## Product Change Notification / SYST-05AYMH316

ERRATA - SAM D11 Family Silicon Errata and Data Sheet Clarification

## SAM D11 Series Family Silicon Errata and Data Sheet Clarification

**FIGURE 35-2 and 40-2: POR OPERATING PRINCIPLE:**

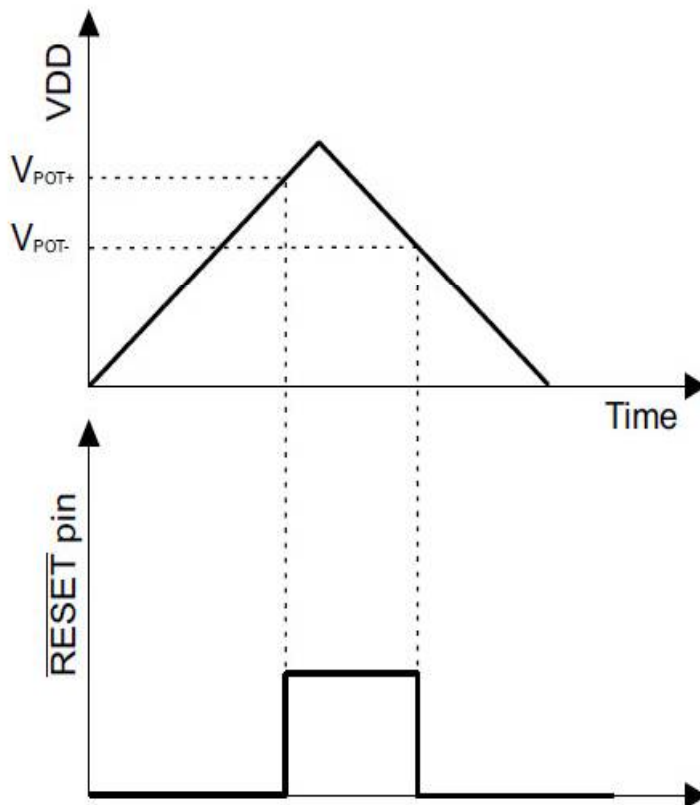
Figures 35-2, 35-3, 35-4, 40-2, 40-3, and 40-4 have an incorrect reset Polarity value. The corrected figures are as shown below:
